VILLAGE OF PALATINE

AGENDA

NOVEMBER 15, 2021

Consider an Ordinance Granting a Final Planned Development for the Architects Corner Development at 1939 – 1967 N. Northumberland Pass

UTILITY PLAN

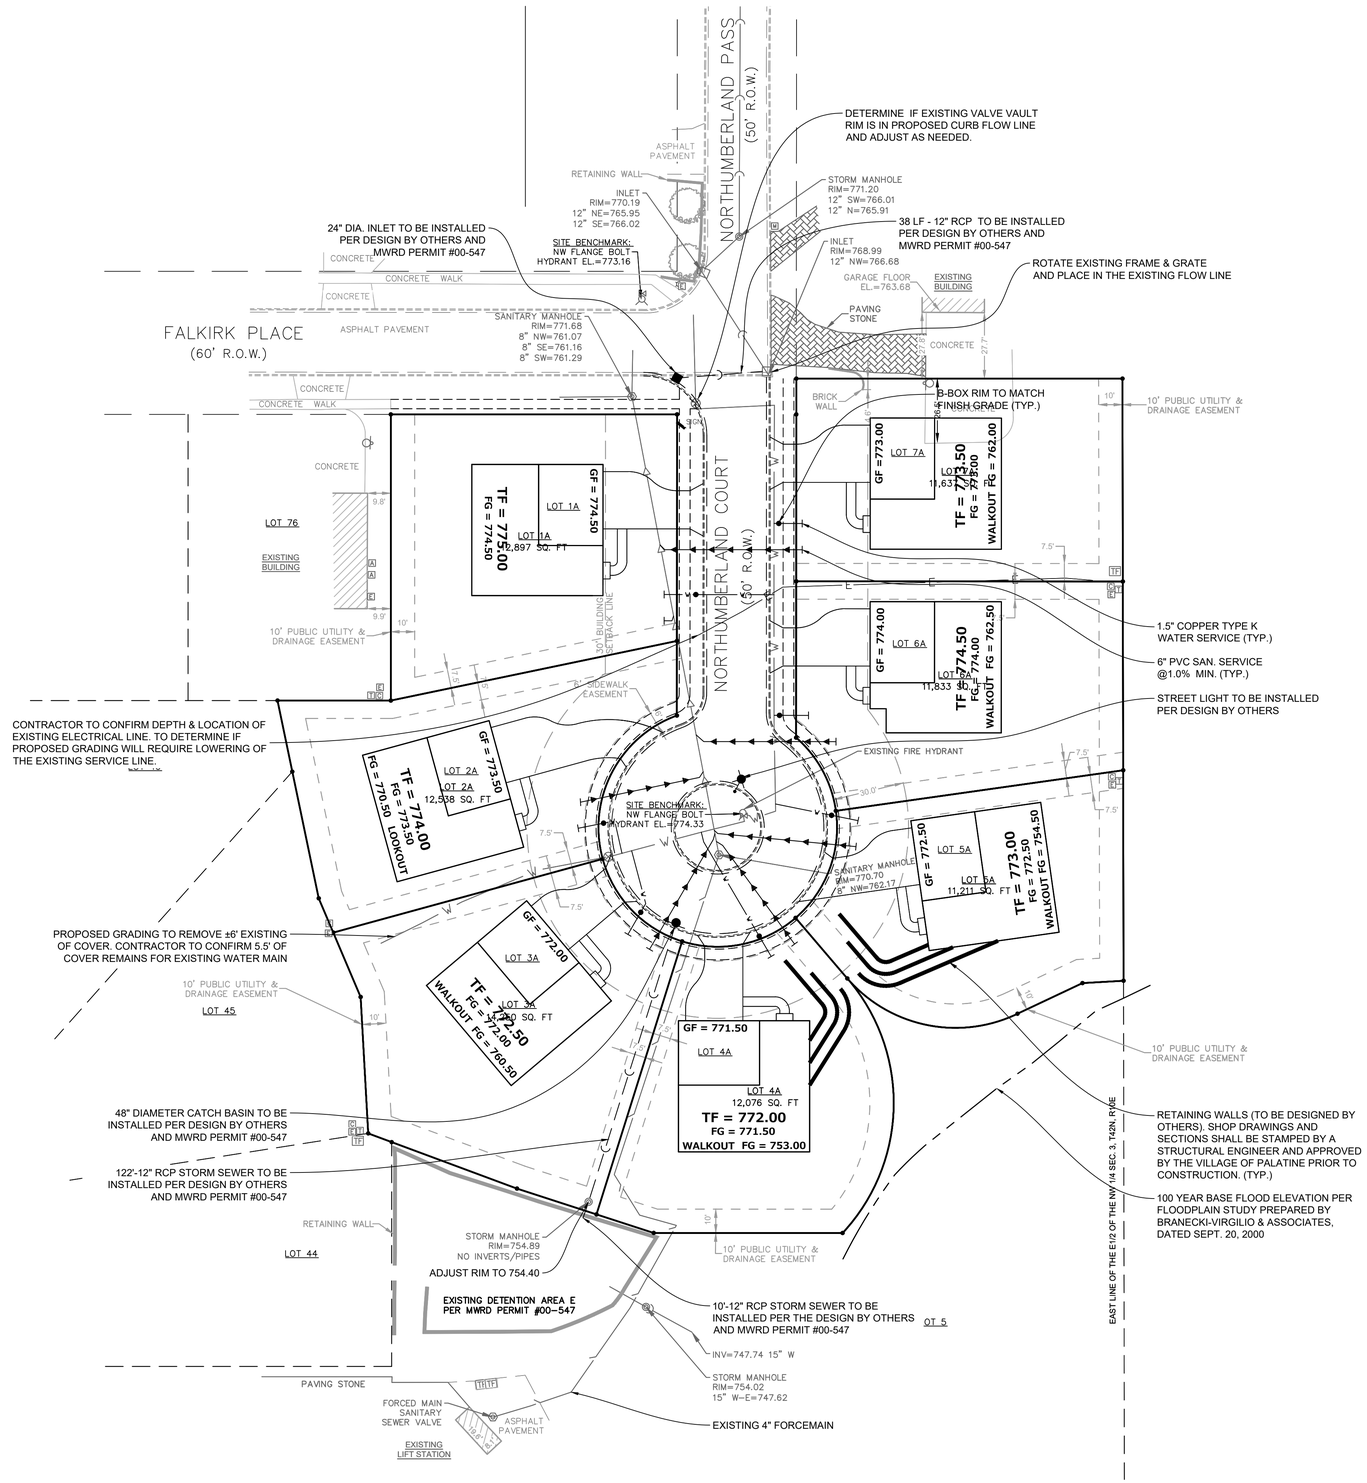
L. Public streetlight shall be LED and have a color temperature of 4000k.
RESPONSE: A note has been added to Sheet C-5, Utility Plan, of the Engineering Improvements Plans.

TYPICAL PAVEMENT SECTION

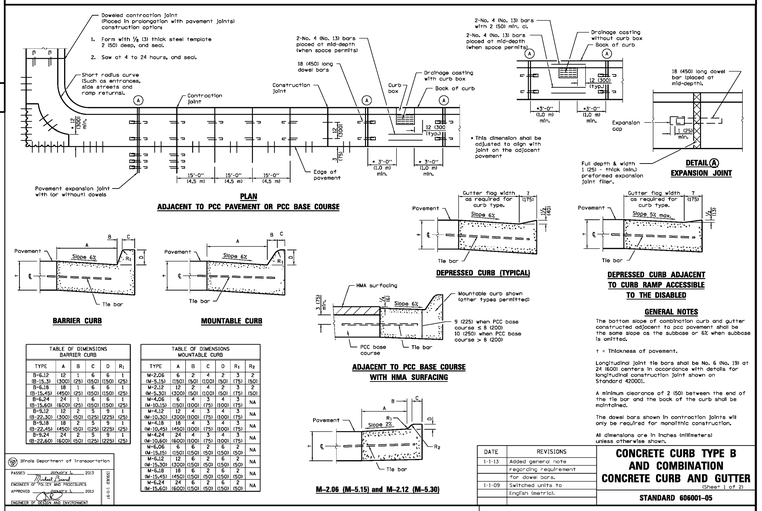
d. To show the Village standard 2" surface course, as shown in the paving detail.

e. To show 12" compacted base course, as shown in the paving detail.

MASS GRADE SCHEDULE

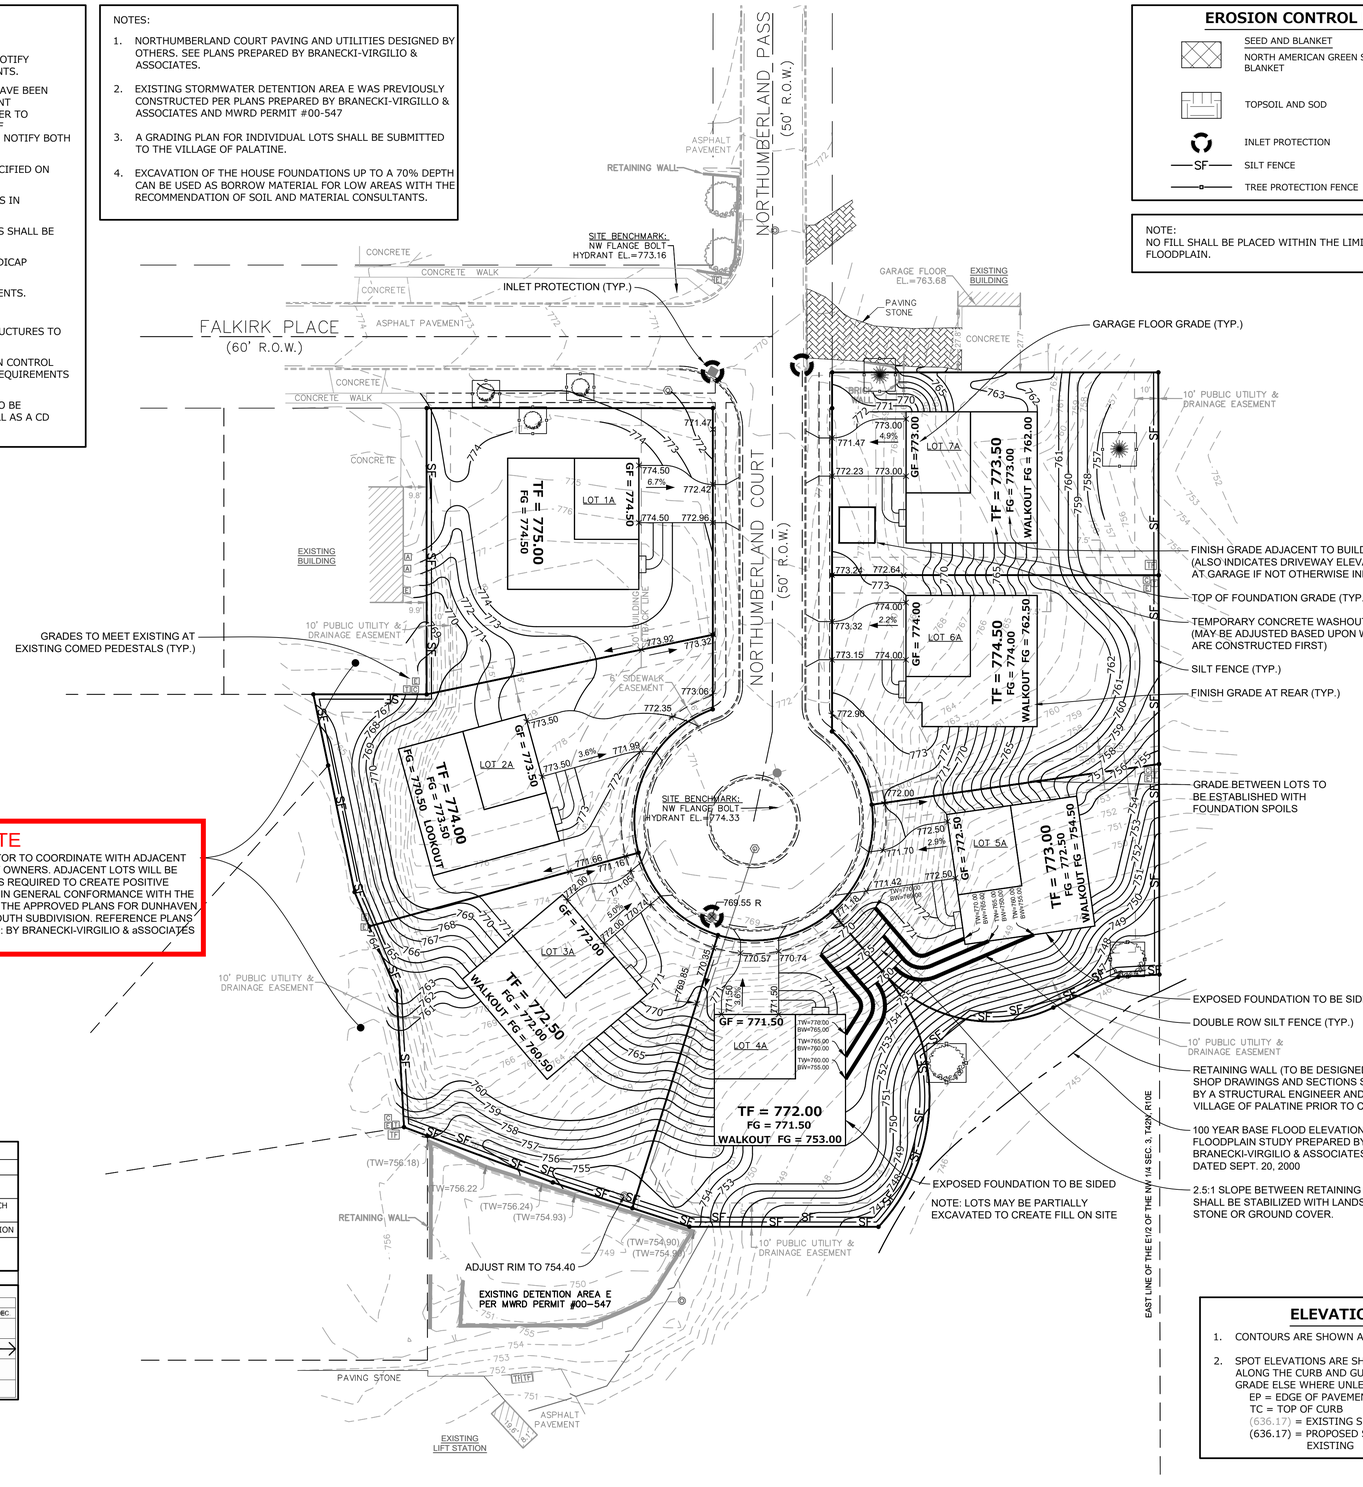
a. **The submission of a mass grading plan and schedule, in a manner acceptable to the Village. Upon Village approval of the mass grading plan and schedule, the mass grading plan for the 7 lots shall be completed by the approved developer and accepted by the Village and secured by the required letter of credit, prior to the issuance of a building permit for any the lots.**

b. **The grading plan and schedule shall be revised to include any required amendments, including any additional required storm sewer work to accommodate proper drainage, needed to restore the original approved subdivision grades for the adjacent offsite lots on Falkirk Place and Hayleys Hill Court. These revisions shall also be included in the Engineer's Estimate of Costs (EEOC) and the final letter of credit amount submission to the Village. Once the mass grading plan and schedule is approved, the development shall coordinate notice and approval of the proposed schedule with the other property owners, in a manner acceptable to the Village.**
